Hume Coal Project EIS Independent Expert Review Groundwater Modelling

Prepared for:

NSW Dept. Planning & Environment

6 Dec.
2017

Figure 1 - mine drainage feature (after Coffey 2016b, Figure 5.4)

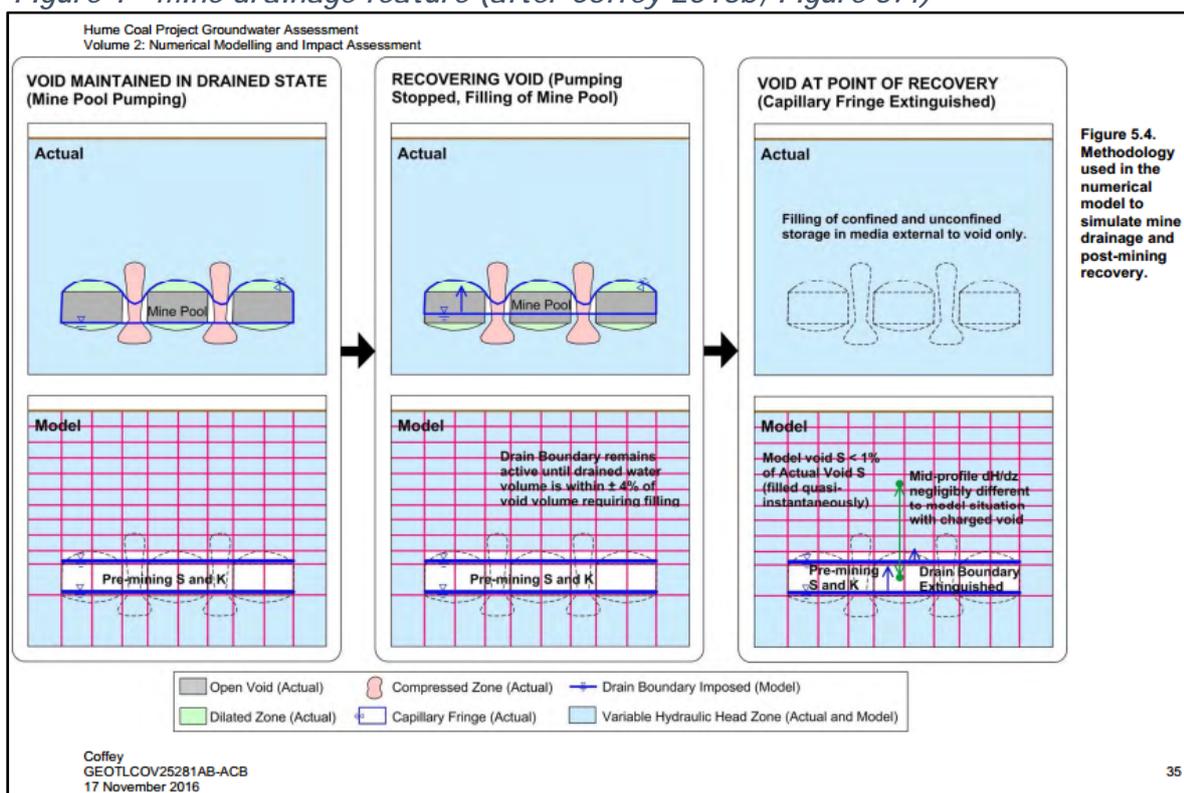
The groundwater-related effects of potential bulkhead failure were not specifically considered in the EIS, but the results that have been provided can be interpreted to provide some useful information on the issue. The groundwater assessment modelling method included leaving drain cells active after mining until the residual void behind the bulkhead is filled, and then deactivating the drain cells (Figure 1).

This allowed unpacking of the volumes reporting “to void” (which in reality would become part of aquifer storage post-mining) separately from the volumes “to sump” (which are used in the mine water management circuit). The volumes “to void” can be considered to be a prediction of the effect of bulkhead failure in terms of water take and drawdown, because the model is actually removing the “to void” volumes from the model via the drain cells, rather than allowing the volumes to become part of the post-mining aquifer storage (as would happen when the drain cells are turned off). Hence the predicted drawdown using this method actually provides an assessment of the drawdown impacts due to the void volume being removed from the model (i.e. as if a bulkhead failure had occurred; or, more correctly, as if every bulkhead fails in turn).

An alternative modelling method has been applied in the latest refinements (see section 2). The revised method involves turning off model drain cells when the mined areas are sealed. The deactivation of drain cells post-mining is a more realistic method, in that the model allows post-mining inflows to become part of the void element of aquifer storage once a mined panel is sealed.

The Hume Coal model applies the “Drain” feature of Modflow to simulate groundwater inflows to the mine workings (a standard methodology); see also Figure 1. The drain feature involves a conductance parameter that acts as a resistance to flow (i.e. lower values of conductance require higher groundwater levels to result in the same amount of inflow).

Figure 2 - Interburden thickness (after Coffey 2016a, Figure 4.3)

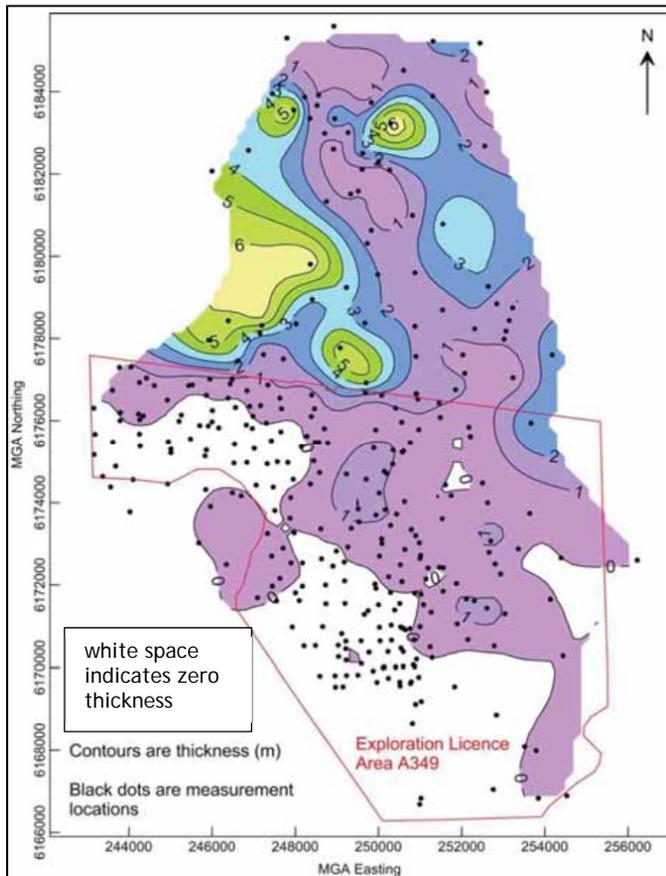
Dr Merrick indicated during review discussions (see Issues Log item 3 in Appendix A) that his internal review of the model identified issues with the implementation of the interburden (layer 8, comprising the combined Narrabeen Group, Wongawilli Ply and Farmborough Claystone) that warranted corrective action in terms of extending the relaxation zone up into layers 6 and 7 in some areas of interburden absence (Figure 2).

- a minimum thickness of 0.4m is applied to layer 8 (interburden) in areas where the interburden is absent (Figure 2), but in those areas, the parameters applied are the same as those for the Wongawilli mined seam;
- a minimum thickness of 0.29m is applied to the underlying layers 9 and 10 (the Permian units between the interburden and the mined seam);
- thus, a combined minimum thickness of 0.99m applies to layers 8 to 10, between the roof of the mined coal seam (top of layer 11) and the base of the Hawkesbury Sandstone, and all these layers have the same parameters as the mined seam.

The report (Coffey, 2016b) confusingly and erroneously describes the thickness of the layer 8 interburden in various ways: average layer thickness of 4m and minimum thickness of 0.1m. Similarly, layers 9 and 10 are described as having an average thickness of 2m and a minimum thickness of 0.1m.

In other areas, the known interburden thickness (Figure 2) is applied to layer 8 of the model, and similarly for the layers 9 and 10 thickness. However, the aquifer parameters applied to layers 6 to 11 are representative of the coal measures (Figure 3). This means that low permeability parameters are not applied to the interburden layer in the model, as illustrated in Figure 3 in terms of the model values for the interburden being much higher than most of the test results for the deep units.

The areas of zero interburden thickness (Figure 2) align with areas where the mined coal seam thickness (layer 11) is less than 2.6m. Appendix A of Coffey (2016b) presents a figure showing

Figure 3 - observed and modelled hydraulic conductivity (after Coffey, 2016b, figure 4.5 and Pells, 2017, figure 2.12)

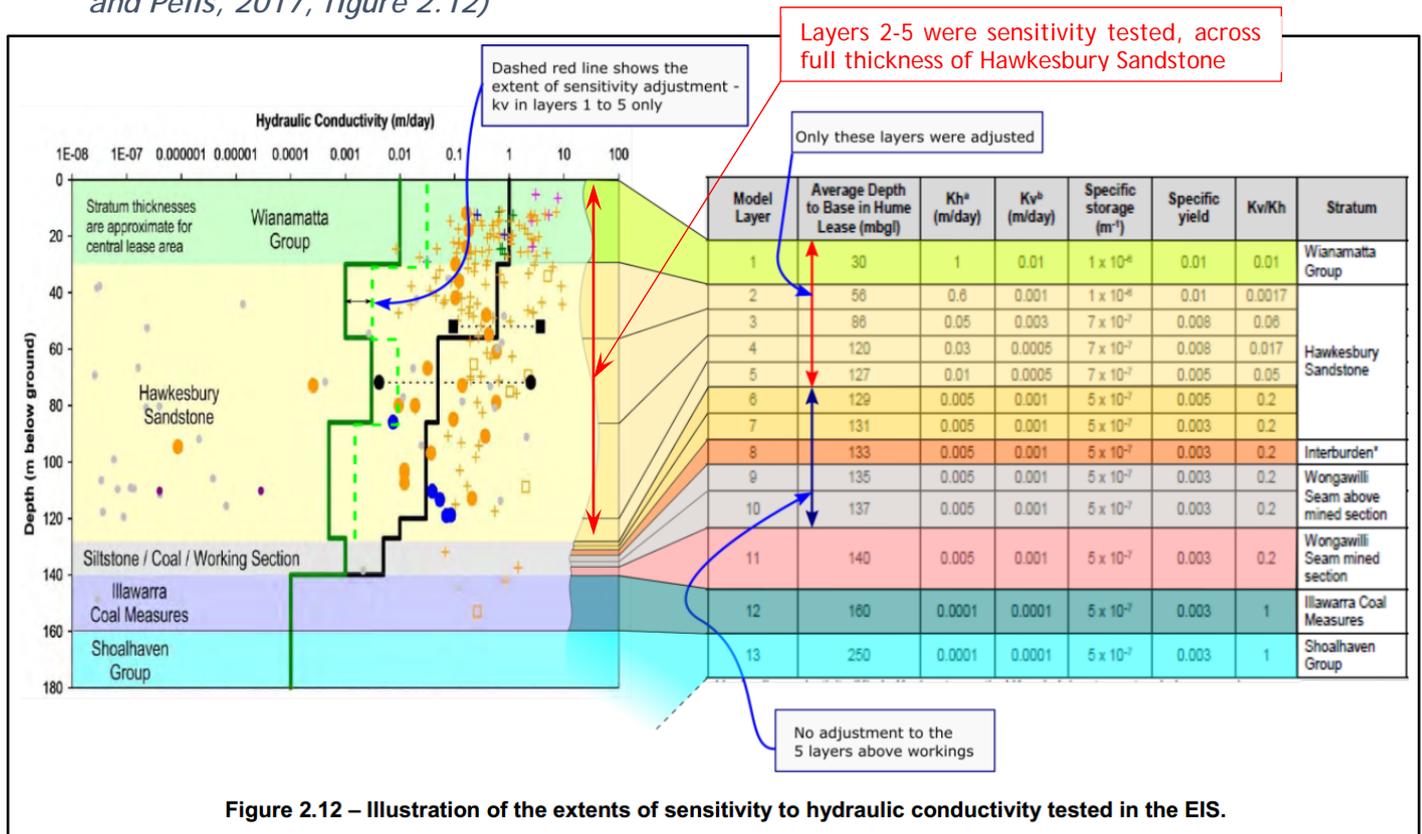
The modelled Hawkesbury Sandstone Kh values are reasonable in that they lie in the middle of the range of observed values (Figure 3); clearly not at the high end of the range as suggested by Pells (2017), but also not at the low end of values (mainly from core testing, indicated by grey dots in Figure 3). Most of the pumping tests on individual bores (open square symbols in Figure 3) do indicate higher range Kh values, but that is for tests mostly in the higher elevations of the Hawkesbury Sandstone, including the two tests on bores on the Hume lease (H98 and GW108194

indicated by the solid black symbols). Again, the model reflects this effect of higher Kh in shallower units. The exception is the high Kh for the (un-named) bore at about 110m depth.
